JAFP-14-0047  
May 1, 2014

SUBJECT: Proposed Change to the James A. FitzPatrick Nuclear Power Plant's  
Technical Specification Concerning the Safety Limit Minimum Critical Power  
Ratio

James A. FitzPatrick Nuclear Power Plant  
Docket No. 50-333  
License No. DPR-59

**GNF Additional Information Regarding the Requested Changes to the Technical  
Specification SLMCPR, FitzPatrick Cycle 22, GNF-PLM-000N6458-R0-NP, dated  
March 2014**

**Figure 1. Current Cycle Core Loading Diagram**

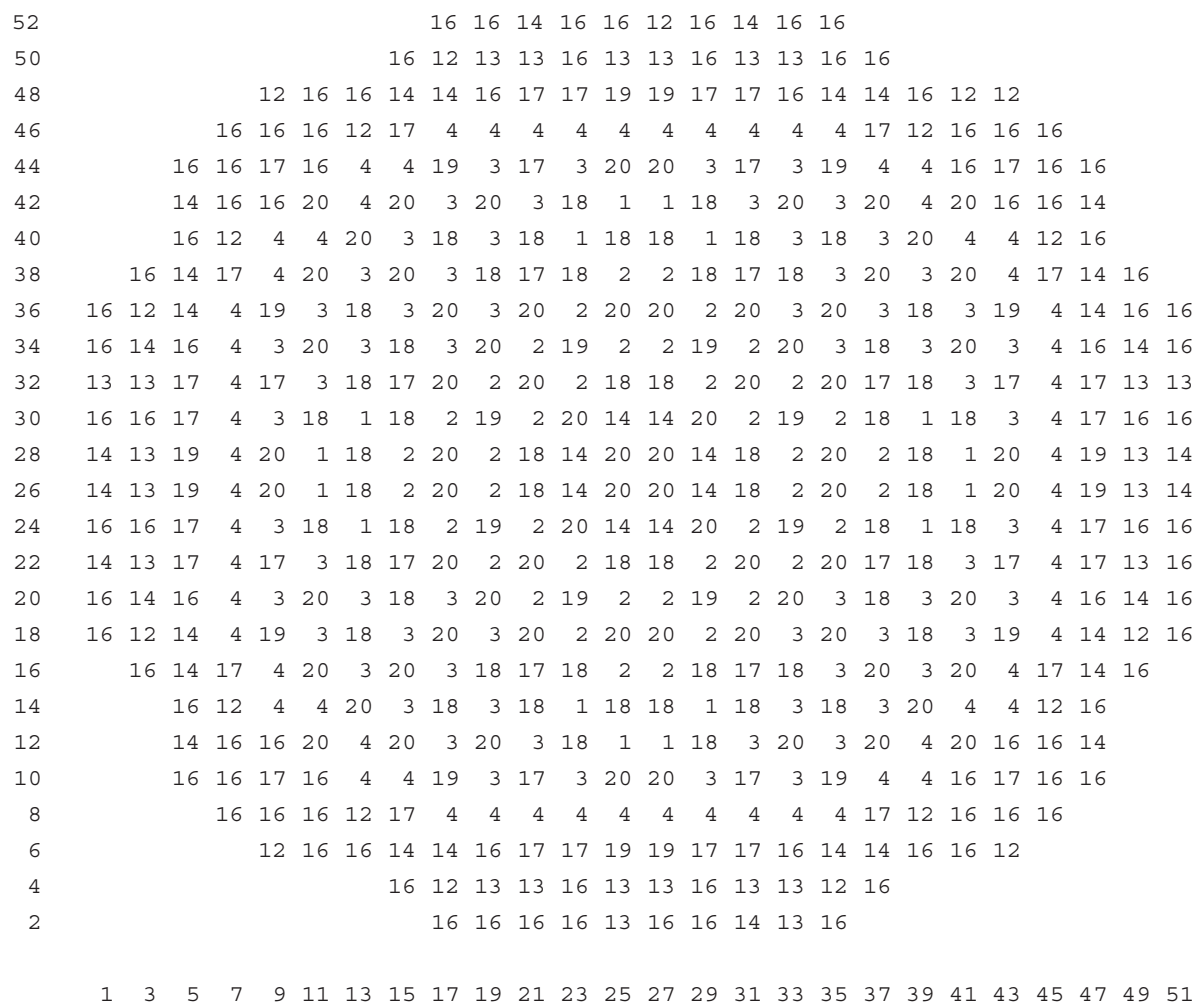
Figures 1 and 2 provide the core-loading diagram for the current and previous cycle respectively, which are the Reference Loading Pattern as defined by NEDE-24011-P-A (Reference 1). Table 1 provides a description of the core.
